1CAN041004

SUBJECT: Supplemental Information to Fourth 10-Year Inservice Inspection Interval
Request for Alternative ANO1-R&R-013
Repairs to the Pressurizer Instrumentation Penetrations
Arkansas Nuclear One, Unit 1
Docket No. 50-313
License No. DPR-51

Response to Requests for Additional Information

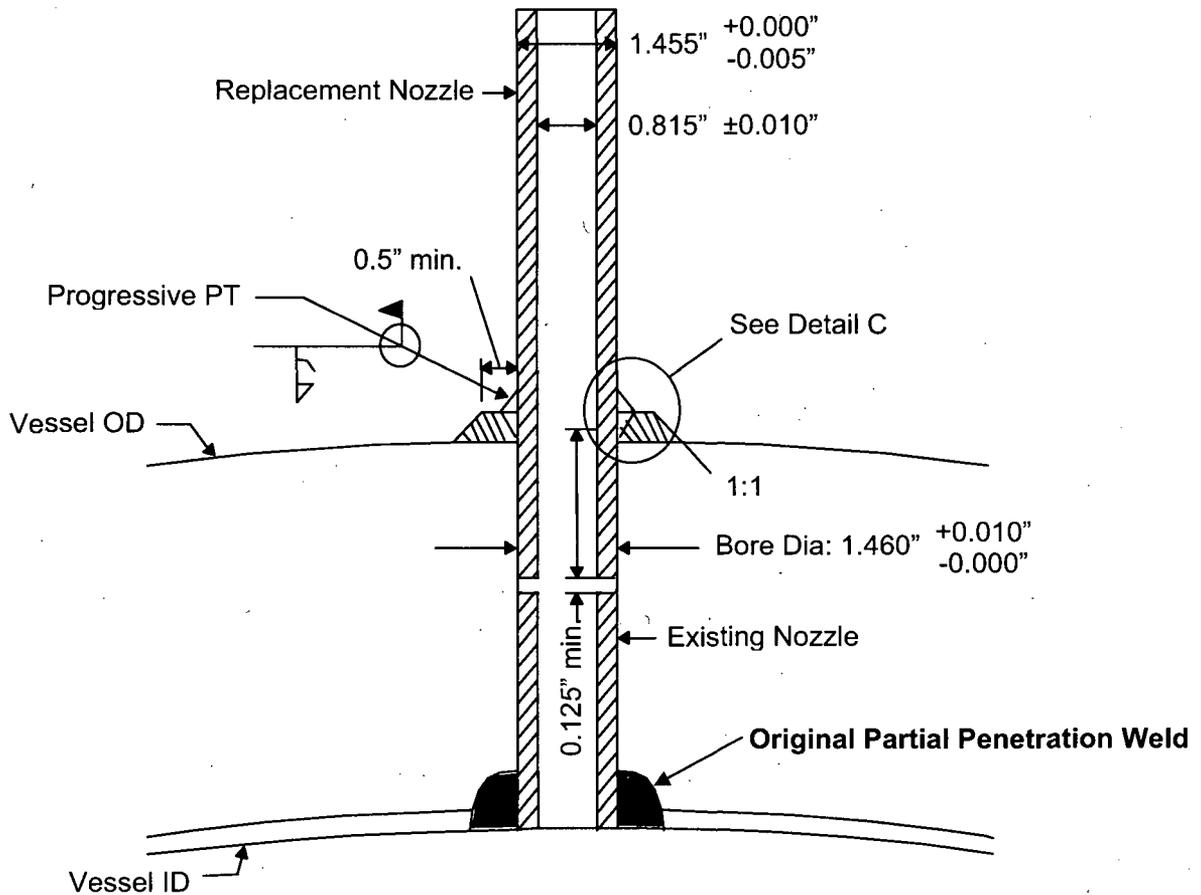
2. Section 4 states that the original partial penetration attachment weld and a remnant of the original nozzle will remain in place. Figure 1 of the relief request shows that a weld pad is installed at the outside surface of the pressurizer shell. Clarify the location of the original partial penetration attachment weld using the diagram in Figure 1 of the relief request.

The original partial penetration weld is located at the inside surface of the pressurizer between the original penetration nozzle and the pressurizer vessel, as shown on Figure 1 below.

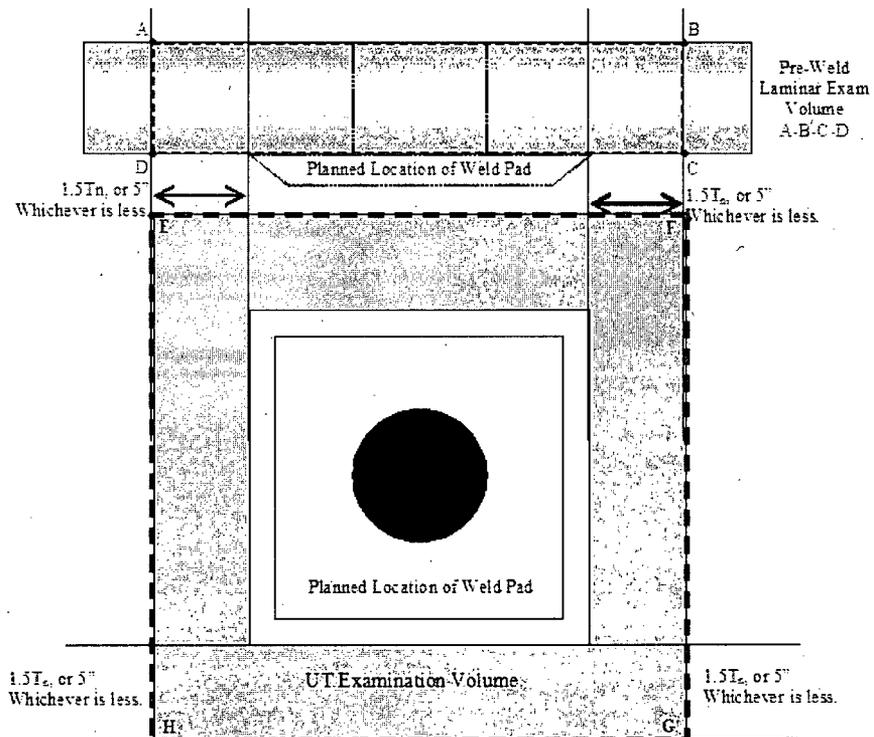
5. Page 4, Item (2), states that a surface and ultrasonic examination will be used to inspect the base metal before application of the weld pad. (1) Provide the exact surface area and volume that will be inspected (use a diagram similar to Figure 1 in the relief request to indicate the examination surface area and volume). (2) Discuss the qualification of the ultrasonic examination (reference the appropriate ASME Code section and subsections). (3) Discuss whether there be a surface and ultrasonic examination performed on the penetration bore after a portion of the original nozzle is removed. (4) Discuss whether the surface of the penetration bore will be cleaned after a portion of the original nozzle is removed and before the new nozzle is inserted.

With reference to Part (1) of the above question, the nondestructive examination procedures require examination of the weld pad location and adjacent areas prior to welding as described below:

- A. Liquid penetrant examination of the base material of the weld pad footprint and 5" around the pad location is performed. This Volume is E F G H as shown in the figure below.
- B. The base material of the weld pad footprint and 5" around the pad location is ultrasonically examined with the Phased Array laminar examination technique (-15° to +15° sectorial scan). This Volume is A B C D E F G H as shown in the figure below.

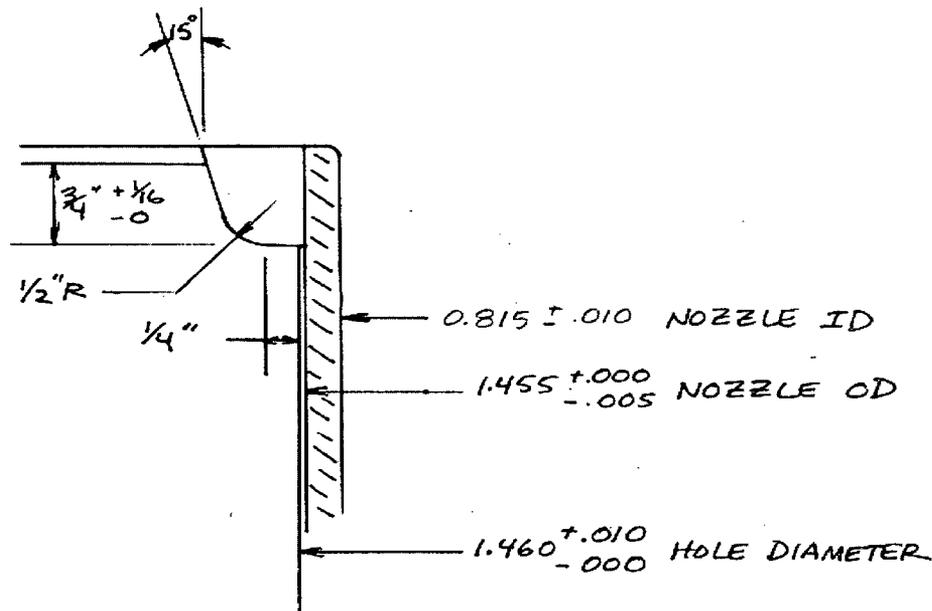
11. The licensee submitted three flaw evaluations, ANO-34Q-326, Revision 1, ANO-43Q-301, Revision 2, and ANO-34Q-330, Revision 0. The staff noted that these evaluations were performed in December 2006 and March 2007. These evaluations state that the analyses are applicable to two upper level sensing nozzles (no existing pad), two lower level sensing nozzles, one sampling nozzle, and one modified level sensing nozzle with thermowell replacement. However, these evaluations do not provide the dimension (wall thickness and diameter) of the nozzles being analyzed. (1) Discuss whether the three flaw evaluations are applicable to the instrumentation nozzle, RC-1001 A/B, in Relief Request ANO1-RR-013. (2) Provide the nozzle sizes (wall thickness and diameter) that were analyzed.

The configuration of the partial penetration weld on the RC-1001 A/B level sensing penetration is shown in Detail D on Entergy drawing number M1G-32. The dimensions of the RC-1001 A/B level sensing nozzle are shown on Entergy drawing number M1G-67. These dimensions are summarized in the sketch below.

The nominal cladding thickness is 3/16 inches as shown on Entergy drawing number M1G-1.

With reference to Part (2) of the above question, the nozzle nominal outside diameter is 1.455", the nominal inside diameter is 0.815", and the wall thickness is 0.32".
